U.S. Department
of Transportation
**Federal Highway
Administration**

In Reply Refer To:
HSST/B-153B

Name of system: NatureRail Quick-Joint / Alternate Wood Species
Type of system: Aesthetic Roadside Barrier
Test Level: NCHRP Report 350 Test Level 2 (TL2)
Original testing conducted by: National Crash Analysis Center (NCAC)
Task Force 13 Designator: SGR46
Date of request: September 26, 2012
Date initially acknowledged: October 2, 2012
Date of final package: January 30, 2013

Annex 1: Wood cover

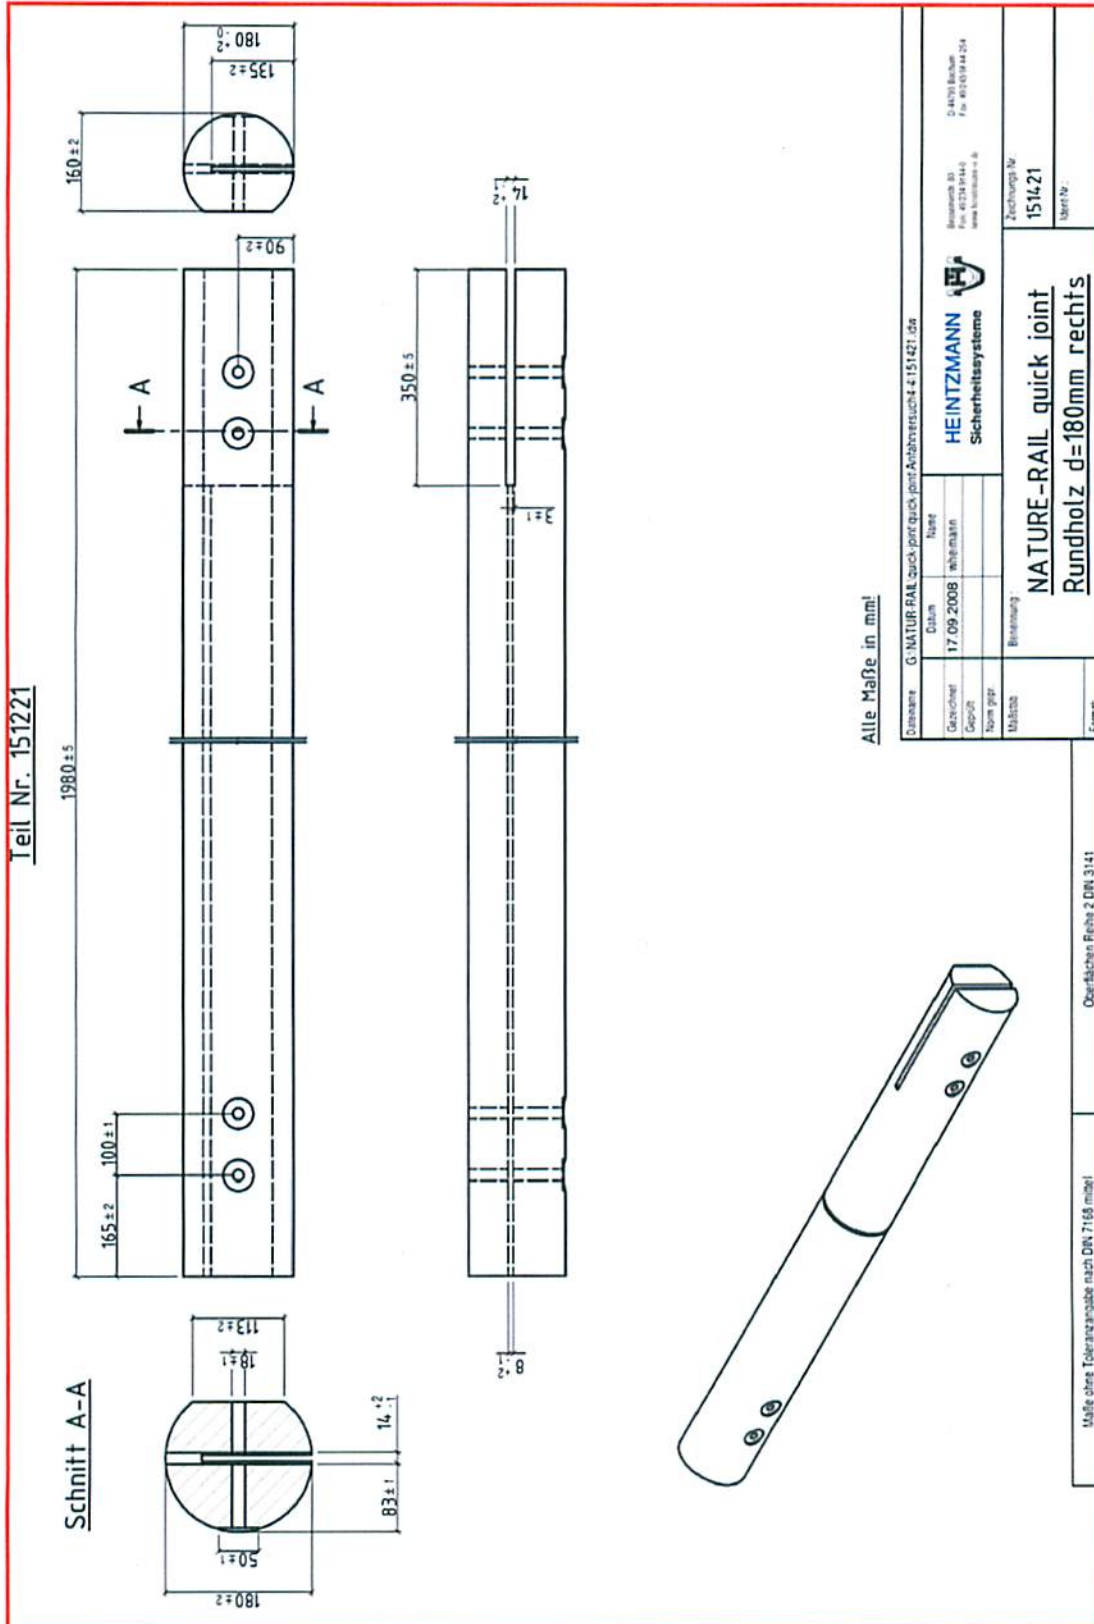
The test item "[Nature Rail Quick Joint](#)" has been tested with wood cover from Norwegian spruce (annex 1).

The considerable part of the impact force will be transmitted by a horizontal steel tension belt in connection with steel posts. From the technical point of view, the wood cover has no relevant influence on the system behaviour and the test results.

Concerning the technical behaviour of the tested item, the wood types listed in annex 2 are to assess as equal.
